90% CONSTRUCTION DOCUMENTS

D.R. HORTON - GRANDVIEW RESERVE
 SANITARY SEWER LIFT STATION
 DESIGN & PERMITTING SERVICES
 EL PASO COUNTY
 PEYTON, CO

CIVIL
 INITIAL-INTERIM EROSION CONTROL

SHEET
C110

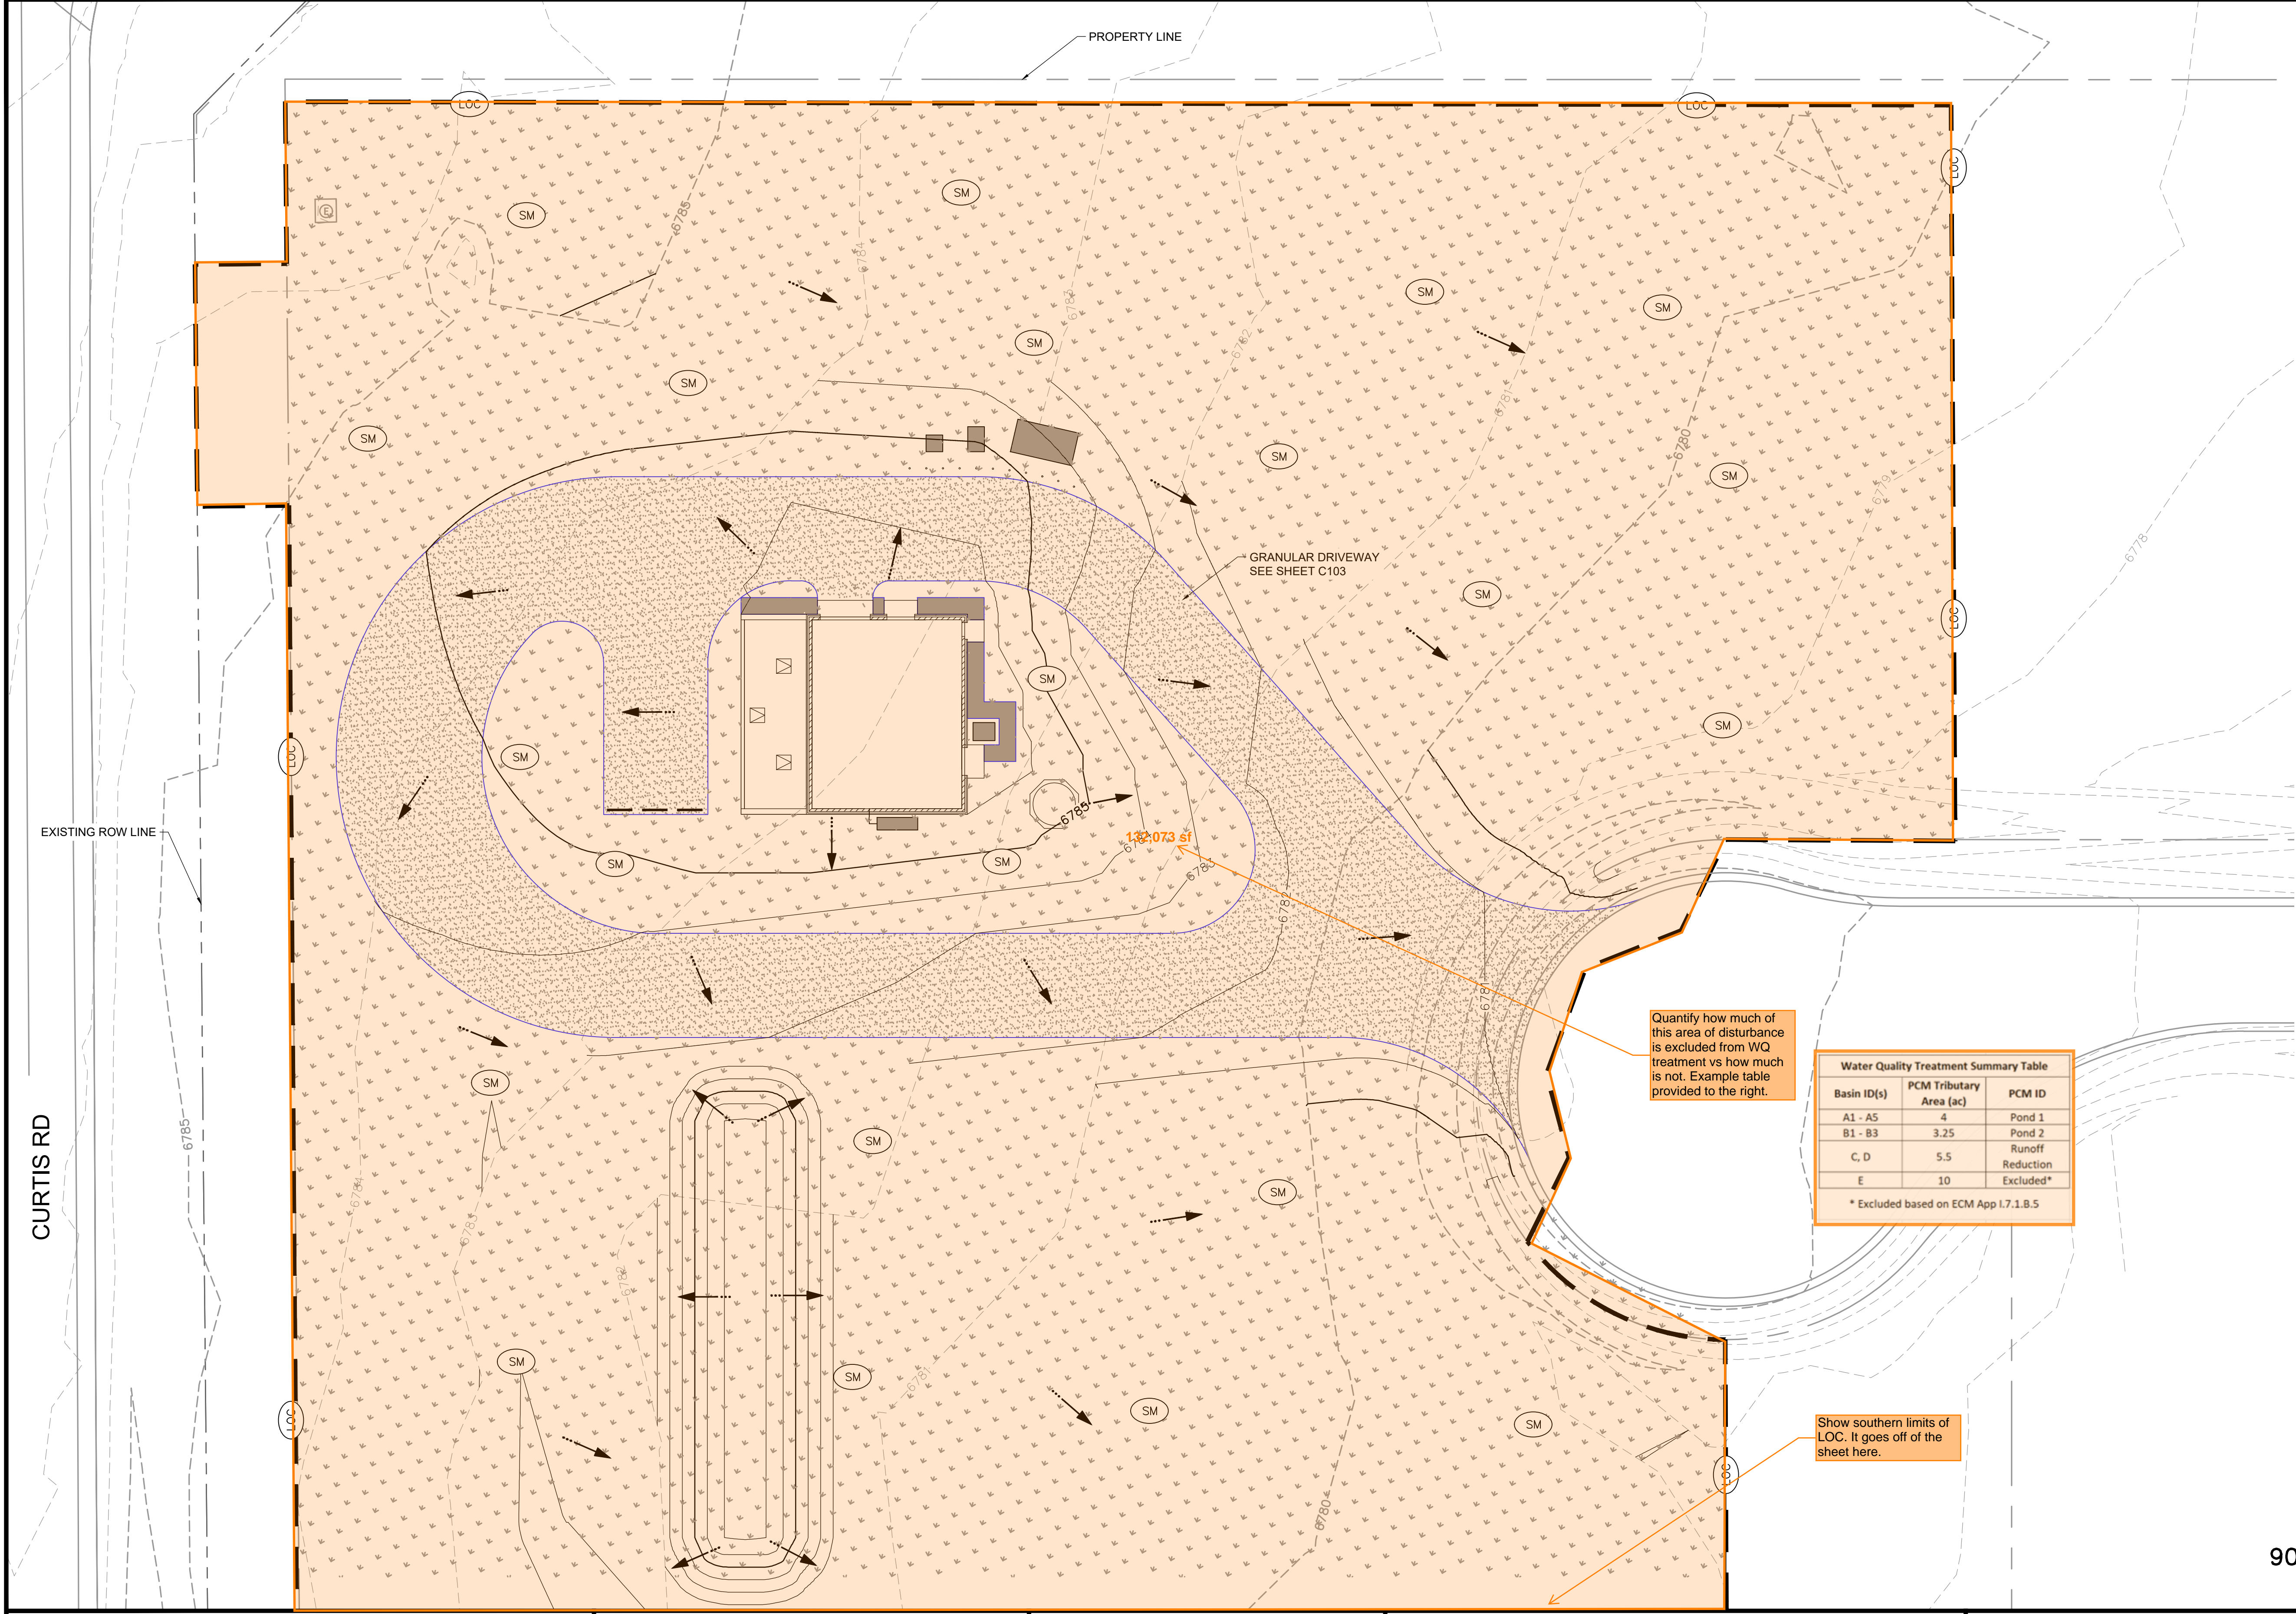
Include Title Sheet from SDP in this GEC Plan submittal. Because the GEC Plan must be submitted separately than a Site Development Plan (SDP) doc.
 GEC Checklist Item "b" - label adjacent parcels/lots.
 GEC Checklist Item "i" - Make a note about the condition/type of existing vegetation.
 GEC Checklist Item "p" - please delineate areas of cut/fill (so include Sheet C102 from SDP)

On the PBMP Applicability Form, it was stated that a WQ treatment facility is necessary for the lift station. But no PBMP is shown on these plans. Please show the PBMP and provide supporting details and calcs (calcs to be submitted in the form of a Drainage Letter with narrative).
 If a PBMP is required you will need some or all of these docs (depending on which type of PBMP):
 - Notice of Intent to Construct a Non-Jurisdictional Water Impoundment Structure (proof of submittal only)
 - O&M Manual
 - Private Detention Basin / Stormwater Quality BMP Maintenance Agreement [download from PCD website]
 - SDI Form or MHFD_Detention Calcs

Provide details for all temp BMPs that are shown on these GEC Plans

GEC Checklist Items H and M. If "limits of disturbance" and "construction boundary" are the same, change to "limits of construction/disturbance" or otherwise show as separate line types for each on the legend and figure.

Show proposed diversion ditches/swales to convey runoff to TSB.
 Provide details of temporary sediment basin including riser pipe diameter and perforation sizing, number of rows of holes, required volume, location of outlet pipe and spillway, and tributary area to the sediment basin. And provide contours for sediment basin.

Show southern limits of LOC. It goes off of the sheet here.

break SF within VTC

label street name
